Reviewer 2 Comments [Uwe Ehret]

Figure 1. Comparison between GraphWavenet and LSTM over the CAMELS dataset. Gages falling in Colorado state are circled. Figure adapted from Figure 8 in Sun et al., 2021.

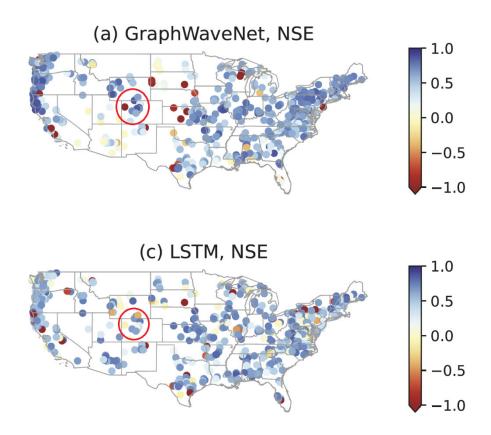
• Also, I have seen many studies where LSTMs were trained on watershed data in the US, in daily time steps, for basins with snow influence, with higher performance. While I see the benefits of the author's approach to emulate high-resolution physics-based watershed models, I wonder what KGE in testing could be achieved by LSTMs simply trained on the available gauges. I suspect they would outperform both the NWM and the GNN. Again, this will not invalidate this study, as the goal is somewhat different. Nevertheless, training an LSTM at least on some or one of the gauges (e.g. at the basin outlet) and presenting the results would help to put the results of the study into perspective.

Reply: We believe the Reviewer is referring to a series of data-driven LSTM papers published by Freddie Kratzert et al. in recent years on the CAMELS dataset. Indeed, their LSTM achieved state-of-the-art performance. However, using the same dataset and also training at daily steps, we showed recently that GNN and LSTM achieved comparable performance in terms of NSE cumulative distribution. In Figure 1, adapted from Figure 8 of our WRR paper, we showed that a pure data-driven GNN is slightly better than LSTM over Colorado watersheds.

So why didn't we take a data-driven approach here? As the Reviewer mentioned, our goal is different. We would like to be able to estimate streamflow at all ungauged locations (nodes) and so far process-based models seem to offer the most meaningful way. Of course, the price we pay is the biases introduced by model errors that are hard to eliminate using fine tuning alone. Nevertheless, after postprocessing, the results become much better. The other fact we'd like to point out is that CAMELS represents a carefully curated dataset that has eliminated anthropogenic effect (such as man-made reservoirs), while half of the watershed in ETW is affected by the Taylor Park reservoir. This human effect is hard to model for even data-driven ML models if the predictors (e.g., reservoir release time series) are not available.
